APPENDIX A - SURVEY AND FULL RESULTS

We're asking for your views on our draft Joint Design Guide - a document that helps make sure new buildings in our area are designed and constructed to the highest quality and sustainability in South Oxfordshire and the Vale of White Horse.

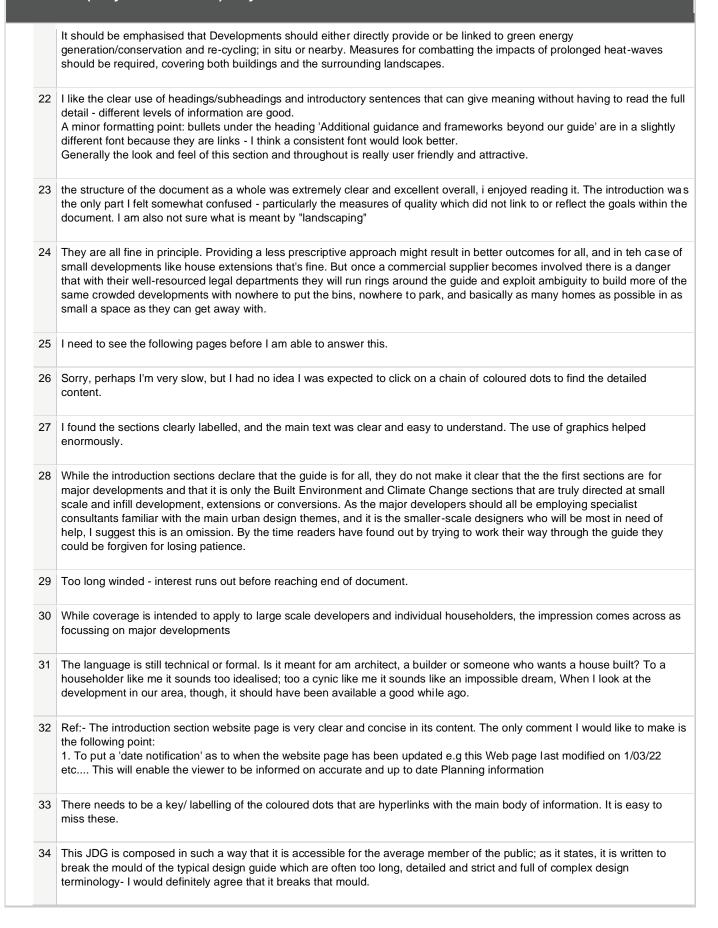
Modern cars espec 4 x 4 's and even new EVs are around 2.02m wide and a shade over 5.0m long if you research. IF THE VALE STIPULATED MANDATORY MINIMUM WIDTH AND LENGTH WHICH WERE PRACTICAL TO PUT A CAR IN AND WIDE ENOUGH SO YOU CAN OPEN A DOOR then a number of substantial benefits:

- 1. New Owners of Garages would be lot happier
- 2. Whole Community would welcome the reduction in the number of cars outside peoples houses in streets and on drives

- 3. Second Cars formerly 'on drive' would be put in garages probably reducing thoughtless useage as have to be 'got out'
- 4. Planning could better use community space around dwellings...wider verges/trees and no parking bays specially built on roads.

- 5. Environment benefits in less-cluttered appearance and more space as less parking-courts made, less tarmac areas.
- 6. Eyesore of Wheeliebins reduces as can put in garage....(especially if planners force house-builders to consder houses have internal-door access into these garages).
